## Whitehouse Planning Commission Meeting Notice

**WHITEHOUSE PLANNING COMMISSION  
PETITION FOR A ZONING MAP AMENDMENT  
STAFF REPORT #02-2019  
May 6, 2019**

**STAFF REPORT  
PLANNING COMMISSION  
PRELIMINARY PLAT APPLICATION  
WHITEHOUSE MEADOWS – STAFF REPORT #03-2019  
May 6, 2019**

**STAFF REPORT  
PLANNING COMMISSION  
Renewal of Preliminary Plats for Steeplechase Plats 6 & 7  
Staff Report #04-2019  
May 6, 2019**

# Steeplechase at Whitehouse Plats 6 & 7

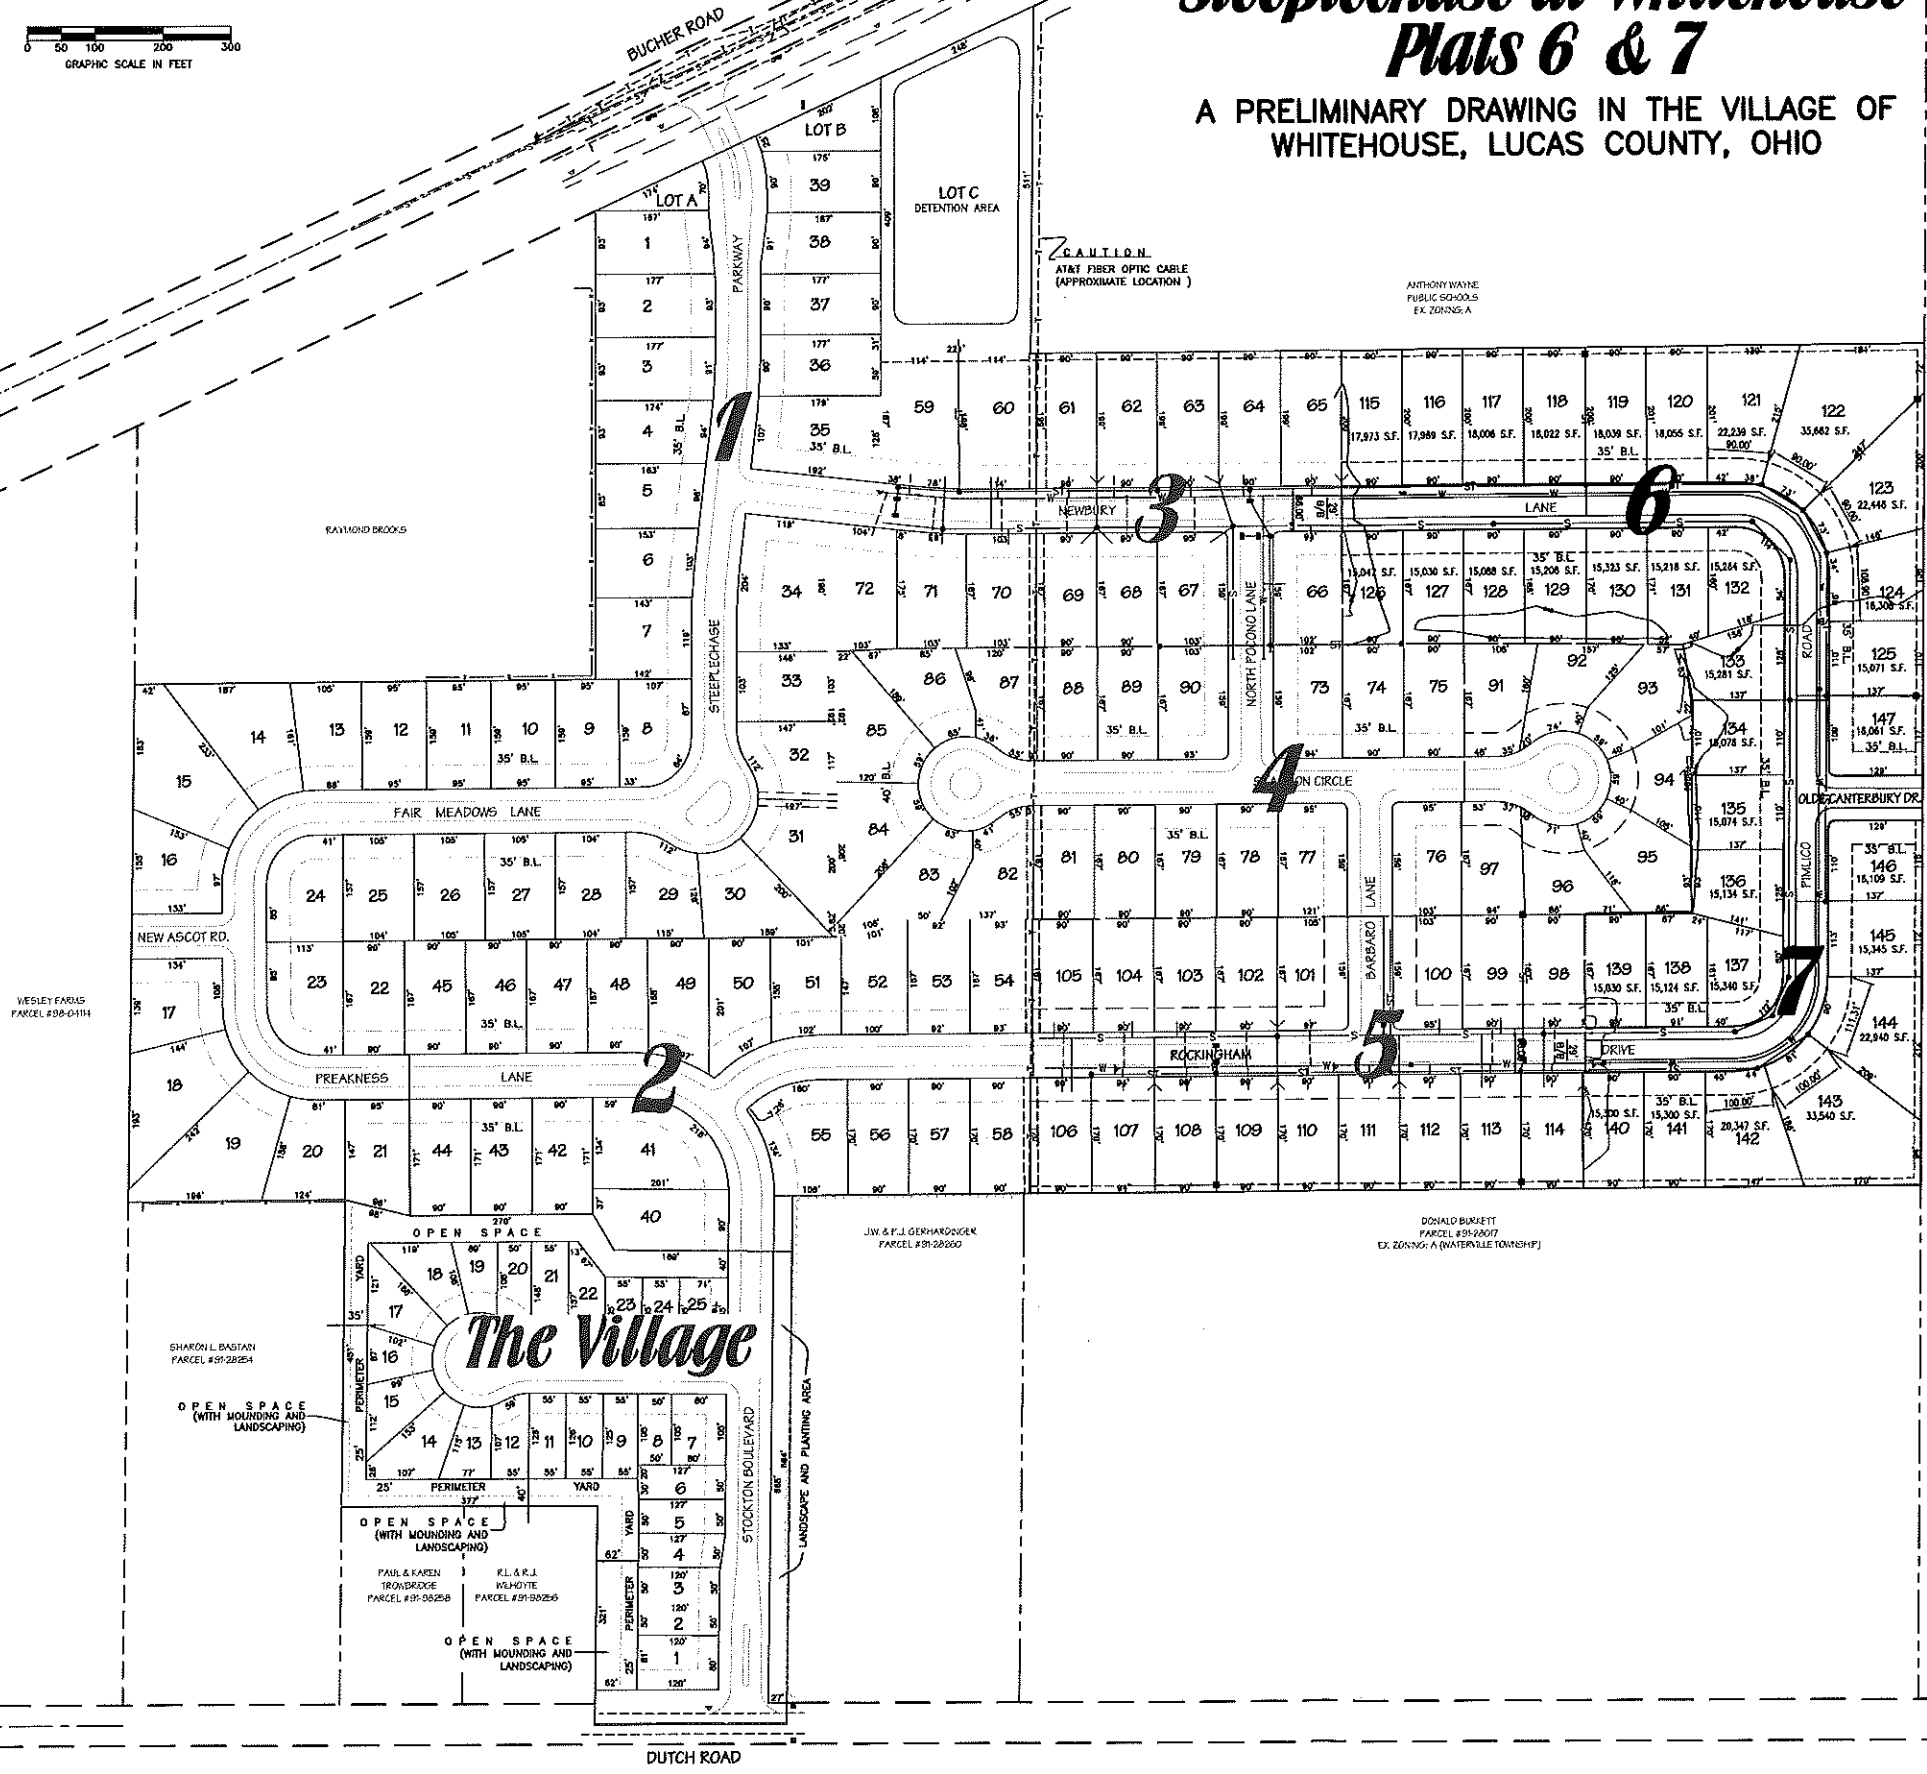
1. Sheet 4 of 4: The invert elevations at manhole 23+39.11 are not correct. The flowline for the 12" sanitary should be 636.63. The invert elevations for the 10" sanitary south also needs corrected. The invert elevation on the 10" plug to the south is also incorrect.
2. Sheet 4 of 4: An easement should be provided around the sanitary sewer extending beyond the plat limits at Sta. 23+39.11.

1. Sheet 2 of 4: See attached sheet for "General Note" comments.
2. Sheet 4 of 4: In profile view, dimension the clearance as "18" Min." at the waterline and stormwater crossings at Sta. 17+68.67 and 23+32.86.
3. Sheet 4 of 4: An easement should be provided around the waterline extending beyond the plat limits at Sta. 23+39.11.
4. Sheet 4 of 4: The Village is now requiring dead end runs of waterlines to have an automatic hydrant/water main flushing device at the end of the line instead of a blow-off hydrant. Please add a Mueller HG-8 Hydro-Guard Automated Flushing System to the end of the waterline. Please note that the system will require a discharge line run to a nearby catch basin.
